3 AN ORDINANCE approving Change Order No. 23,  
4 in connection with Division I, Water Pollution  
5 Control Plant Additions.

PROJECT WATER QUALITY CONTROL PROJECT OWNER CITY OF FORT WAYNE, INDIANA

DIVISION/~~SEKXXXX~~ 1 - Water Pollution Control Plant Additions

CHANGE ORDER NO. 23

CONSTRUCTION JOINT REPAIR DETAIL,  
LOCATED IN EXISTING AERATION PIPE TUNNEL

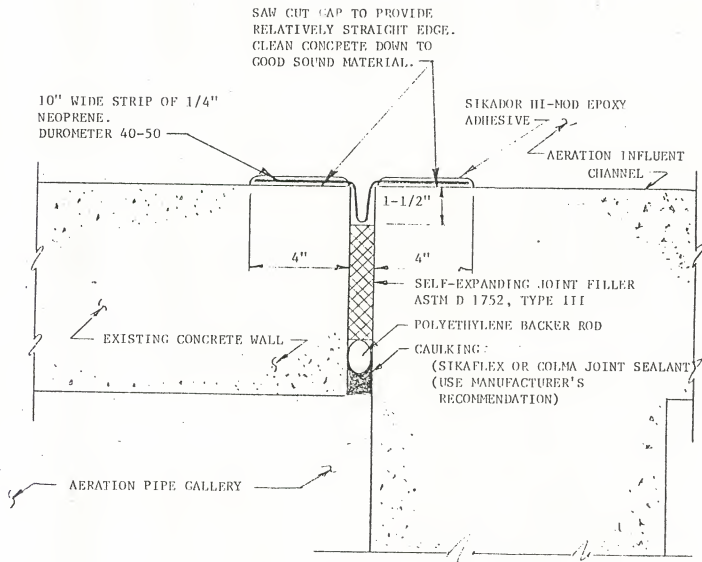
Furnish all labor and material necessary to repair the existing water leak at the construction joint in the aeration influent channel. See attachment "A" for details.

1. Necessity for change: This change is required to repair an existing water leak at  
the construction joint between the original plant aeration tank, which was  
constructed in 1939, and the tanks that were built in 1960. The waterproofing  
material used in 1960 has deteriorated over the past 18 years and allows ground  
water to enter the tunnel and damage electrical equipment. The hydrostatic  
pressure exists during heavy rains, in the spring and when the Maumee River,  
approximately 100 yards from the aeration tank, is at high water.

## ATTACHMENT "B"

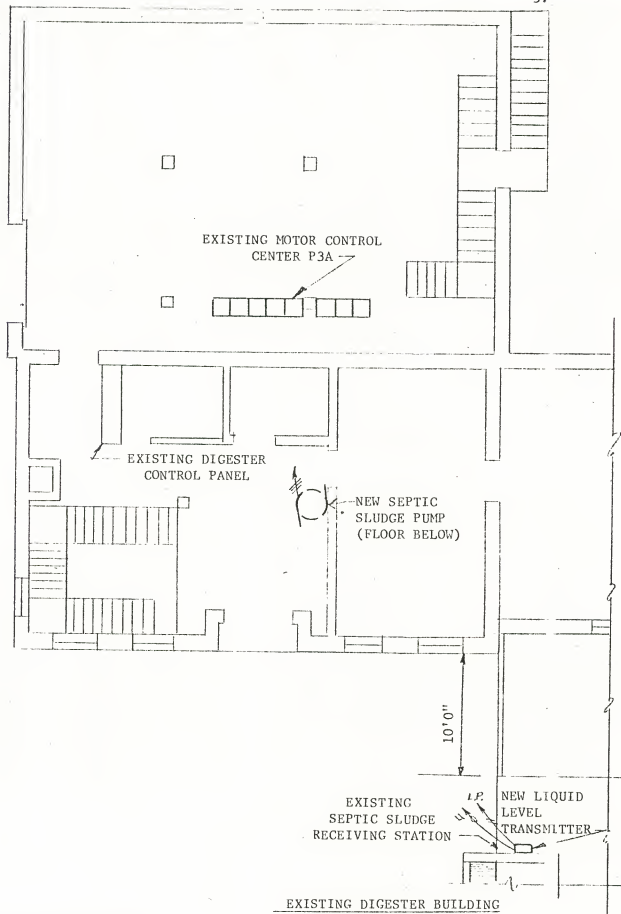
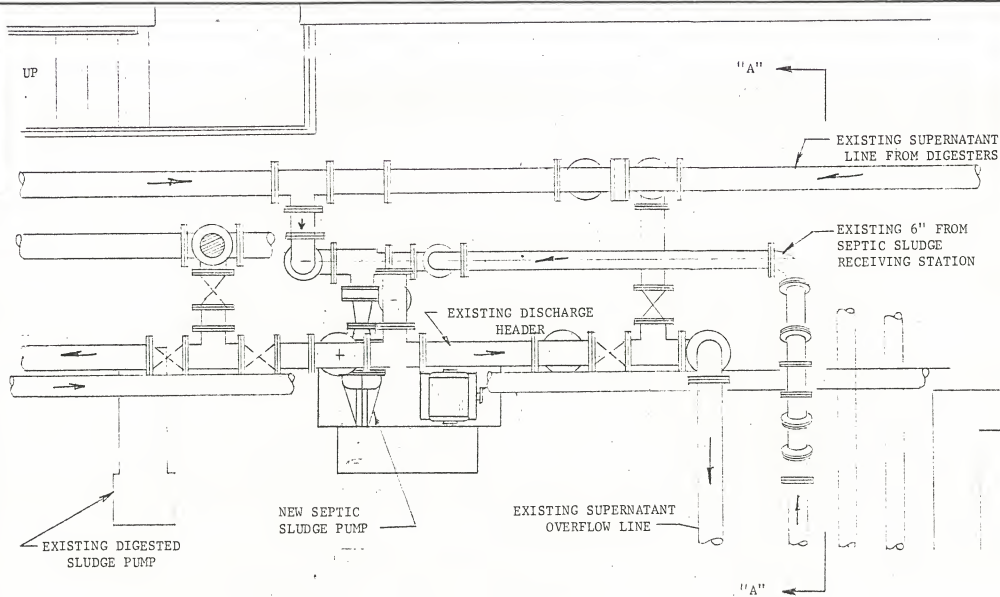
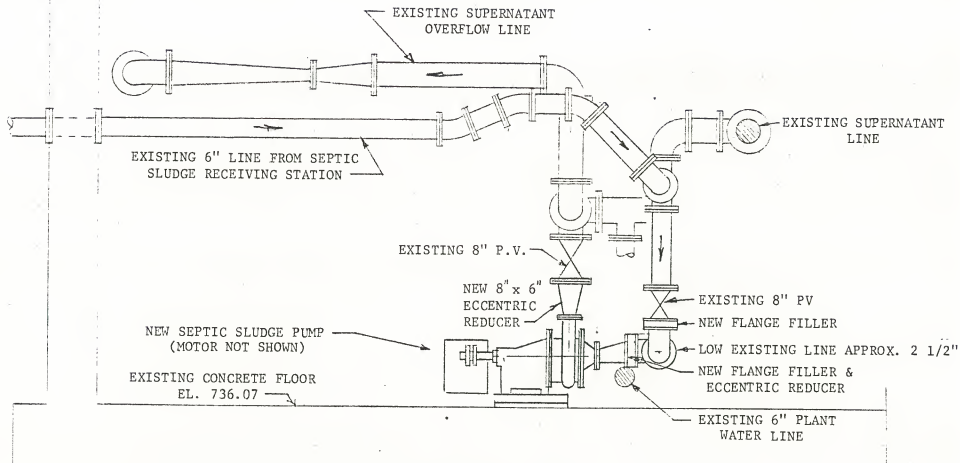
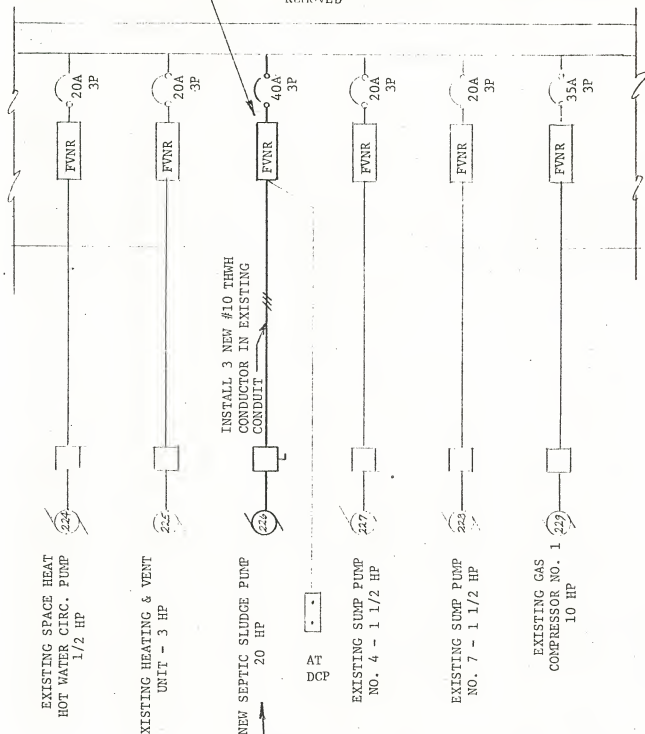
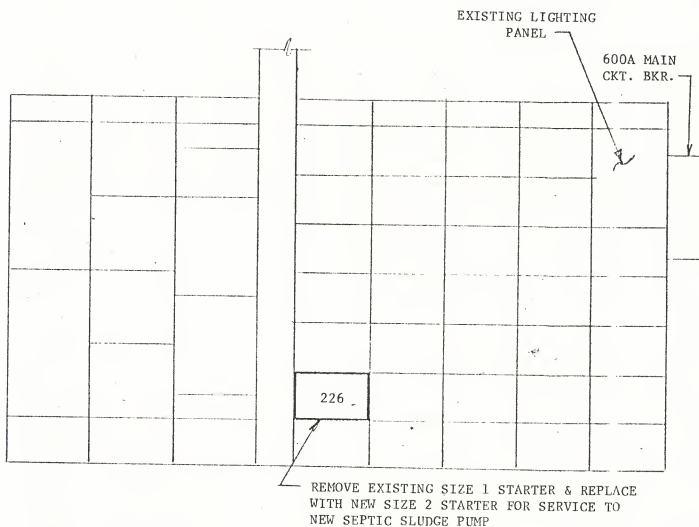
Furnish all material and labor necessary to remove an existing digester supernatant pump and replace with a new septic sludge pump. See attachment "B" for specifications and installation details. Following is a breakdown of added cost:

1. Necessity for change: This change is necessary because the existing pump is un-  
able to handle the problem materials which are found in septic tank wastes. The  
installation of the proposed pump should greatly reduce clogging and the associated  
maintenance and pump wear problems.

Remove existing 4" Chicago model HBB supernatant pump and disconnect electrical service.

Remove existing concrete base.

Lower existing 8" pump suction line approximately 2 1/4".

Replace existing 8" x 4" reducer fitting on pump discharge line with new 8" x 4" eccentric reducer.

Replace existing 6" x 4" reducer fitting on pump suction line with new 6" x 4" eccentric reducer.

Replace existing 6" flange filler as required on pump suction line.

Set new pump and grout as required to raise pump to meet existing suction piping.

Remove existing size one starter from MCC-P3A and replace with new Size 2 FVNR starter.

Remove existing conductor between existing pump and starter.

Install 3 new #10 conductors in existing conduit extending between new pump and MCC-P3A.

Install new disconnect at new pump.

Install new 6" vent pipe 8' high through top of existing septic sludge receiving station.

INSTALL NEW SIZE 2 FULL VOLTAGE NONREVERSING  
STARTER IN SPACE VACATED BY STARTER BEING  
REMOVED

REMOVE EXISTING SIZE ONE STARTER & CONDUCTORS  
WHICH SERVICES EXISTING 3 HP SUPERNATANT PUMP  
THAT IS BEING REMOVED.

SHEET NO.  
**C.O. 23,10**

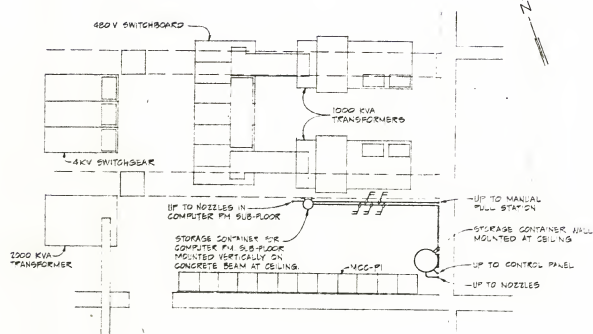
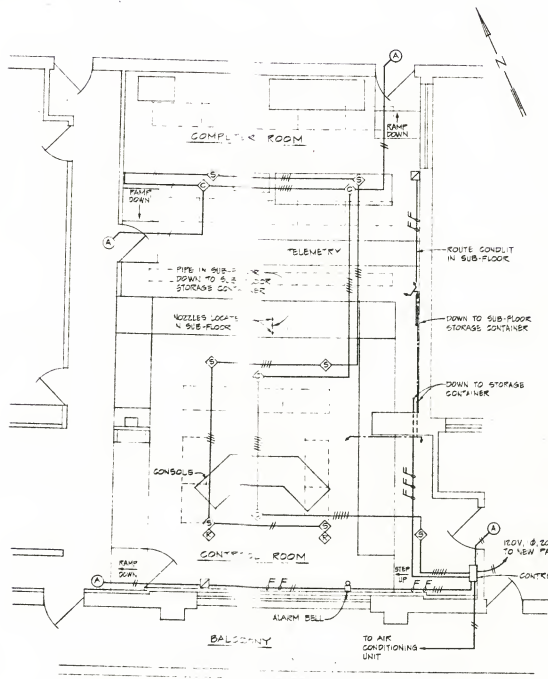
1. Necessity for change: The addition of a new Fire Suppression System in the new control and computer room is recommended because approximately \$1,000,000 worth of equipment will be located in these rooms. The components involved relate to the plant control system With potential for electrical wires within the rooms. There could be a short, hot wire or loose contact to start an electrical fire and without some protection, a portion of the system could be damaged and result in damage of other units: If damage were to occur, replacement and repair costs could be extensive loss would hinder the plant operation severly.
